CLIENT - Zoe Mitchell and Wayne Newman

SITE - Land To The Rear Of 82 St Johns Road, Hedge End, Southampton, SO30 4DF

PROJECT - Landscape and Ecological Enhancement Planning Condition Report

REPORT DATE - 22nd October 2024 Rev A 09/01/25 Rev B 17.01.25

Appendix E: Mitigation and Enhancements

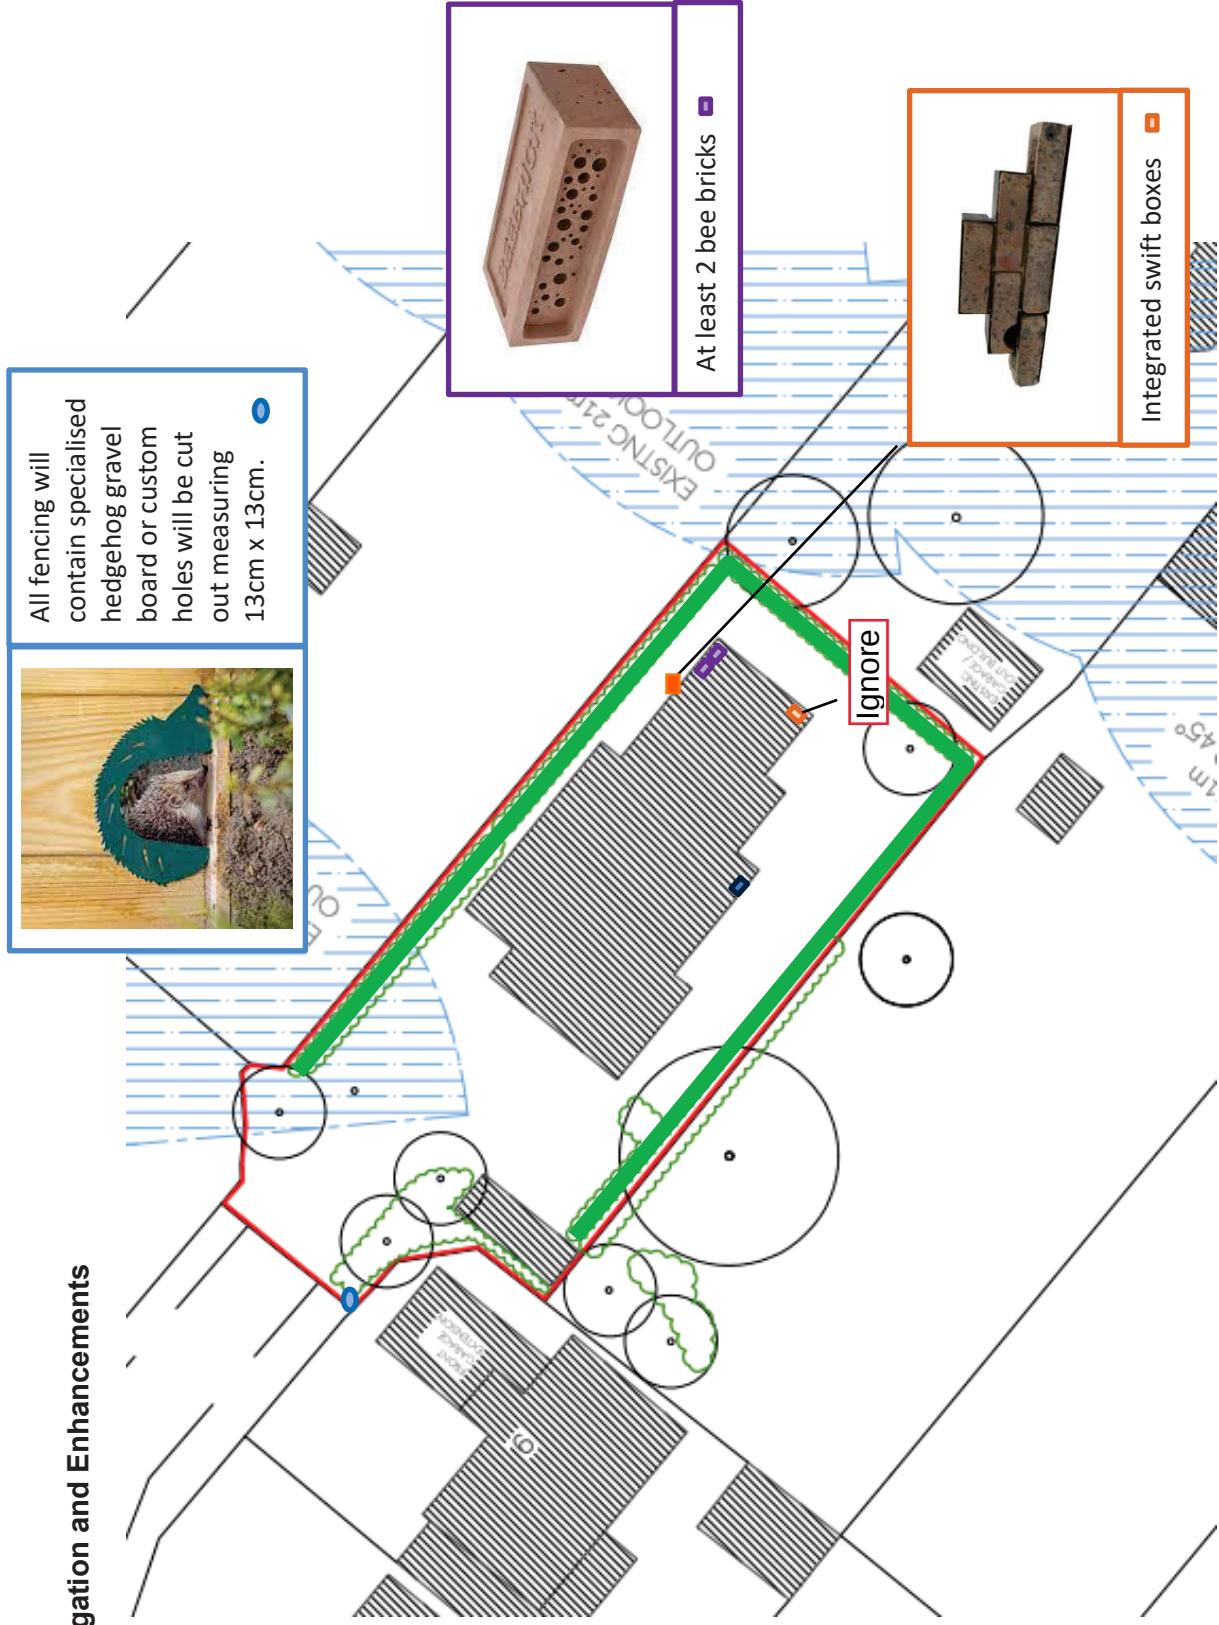
6.3 Bird Boxes – Relocation of integral swift brick to North East elevation a minimum of 5m above ground level.

Note - Following comments from the HCC Ecology Team the Swift Brick will be relocated to the NE corner under the Eaves at least 5m above ground level

6.3 Bird Boxes –1x integrated Swift Brick at eaves level on the North Eastern elevation (Appendix Two and Three) minimum of 5m above ground level.

LIGHTING PLAN

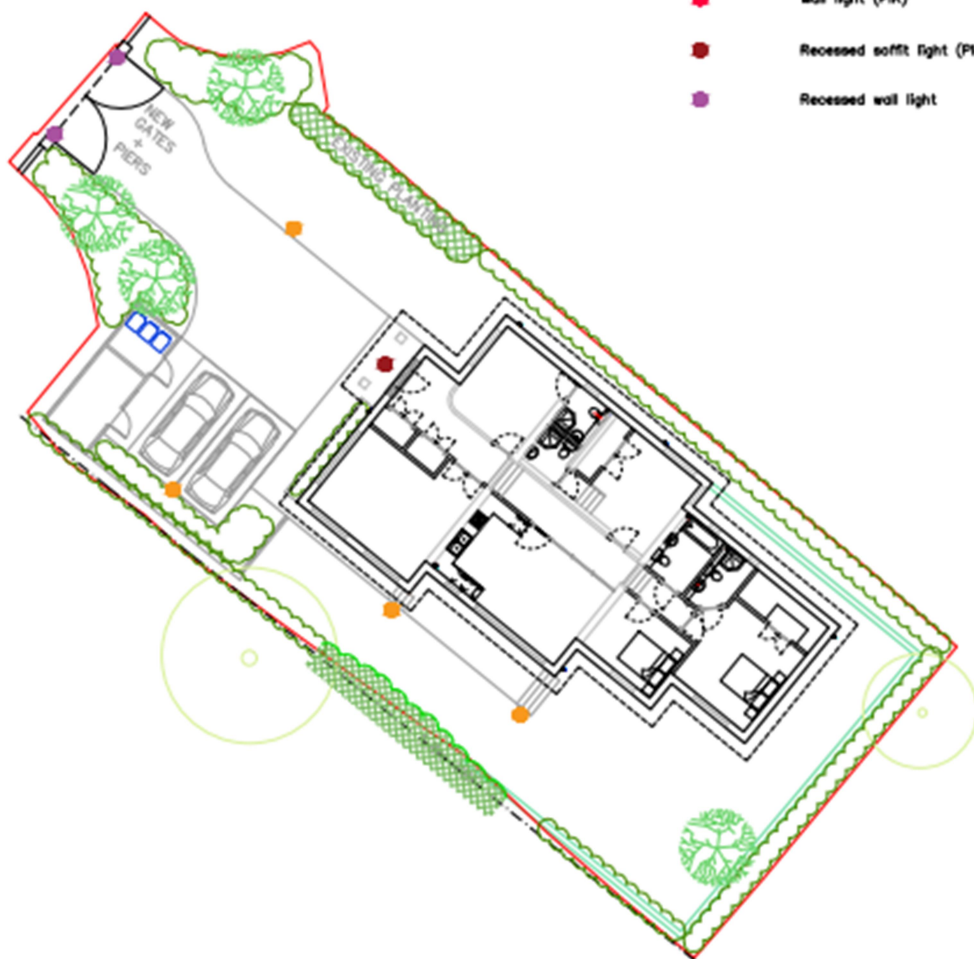
6.8 Lighting – Replacement of wall lighting with low-impact lighting bollards of 1 lux.

A | 15.05.25 | Wall lights omitted
not shown

6.8 Lighting – A low-impact lighting scheme has been designed by the Architect to satisfy Condition 11 a copy of which can be found in Appendix Four. As a result of the ecology consultation response, the wall lights have been replaced with low-impact bollard lighting of less than 1 lux to avoid light spill.
